Our Ref: 15756
DPE Ref: SSDA 7317 MOD 5

SSDA 7317 MOD 5 – RESPONSE TO SUBMISSIONS

This Response to Submissions (RTS) letter is submitted to the Department of Planning & Environment (the Department) in support of Modification 5 to amend State Significant Development (SSD) consent SSD 7317 relating to the construction of a commercial campus at the Australian Technology Park, Eveleigh.

Figure 1 Proposed door at the junction of Building 2 and the travelator tunnel

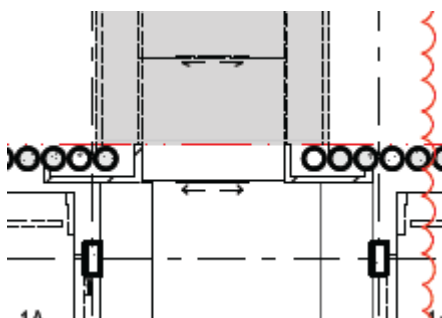
Provide plans/ details to demonstrate how the concrete base structure will be capped at the boundary between SSD 7317 MOD 5 and SSD 8517 as well as any interim works at the junction to the Building 2 basement.

During the construction works and until such time that the travelator is fully functional, the concrete base structure will be capped at the boundary between SSDA 7317 and SSD 8517 by hoardings and hoardings will also be used at the junction of Building 2.

Whilst glazed doors are intended to be constructed at the junction of Building 2 and the tunnel as shown on Architectural Drawing AR-DWG-BB-B2- 300L (**Figure 1**), the exact junction detail between Building 2 and the tunnel is likely to be developed as part of the construction certificate documentation for CC5 – External Works for Building 2.
